December 15, 2010

Re: Feasibility Study Addendum
2350 Fifth Avenue, New York, NY
NYSDEC Site #231004

Response to Comments

revised
4

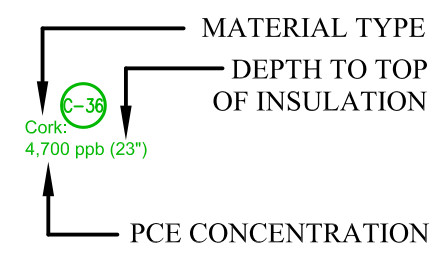
- 3. Figure 5 indicates that the portion of the site where contaminated insulation material and subsurface soil contain tetrachloroethene (PCE) above the SCO (1.3 ppm) are proposed for no further action based on the soil vapor intrusion evaluation. The Department disagrees with this conclusion. As presented in Figure 15 of the Remedial Investigation Report dated June 2010, PCE is present in sub-slab vapor at concentrations above 1000 $\mu\text{g}/\text{m}^3$ around the northwest portion of the site. With the sub-slab concentration of 1000 $\mu\text{g}/\text{m}^3$ or above the NYSDOH matrix for PCE recommends mitigation.*

- 5. Section 5.6 indicates that the preferred alternative is Alternative 4, which consists of in-situ soil and groundwater treatment including an SVE system to address soil and an SSDS to address soil vapor and insulation material. The Department disagrees, and recommends that source removal to the extent practical, including excavation and off-site disposal of the contaminated soil and insulation material, be included in the selected remedy.*

- 6. The department is considering the proposed treatment option plus the removal of the insulation material to the extent practical.*

This FS Addendum revises Alternative 4, and specifically I2, to include partial removal of sub-slab insulation in a maximum 1,200-square foot area, to the extent practicable, in the northwestern portion of the site, as shown on the attached Revised Figure 4.

As discussed in a meeting with NYSDEC on December 1, 2010, the maximum removal area encompasses the area with the highest PCE concentrations detected in the insulation material, as shown on the attached Revised Figure 4. As the sub-slab insulation material is different from a traditional soil matrix, based upon different physical properties and being isolated with a concrete slab both above and beneath the material, the NYSDEC Soil Cleanup Objectives are not applicable. The removal of contaminated insulation from this area would result in contaminant mass reduction for this media in excess of 90%. A table summarizing the mass calculations is provided in Appendix C.

During remedial design, additional insulation sampling would be completed to confirm the presence of insulation within the targeted area shown on Revised Figure 4 and confirmatory samples would be collected for laboratory analysis. The targeted removal area could be reduced in consultation with DEC based on this additional sampling. A structural engineer would be consulted to confirm potential demolition areas and protection of the existing building. Plumbing and electrical trades would be consulted for evaluating and disconnecting existing utilities in the removal area. If the sampling identifies significantly lower concentrations than those identified as part of the FS or significant limitations are identified due to structural concerns, utility conflicts, or other considerations, the targeted area for insulation removal may be reduced.
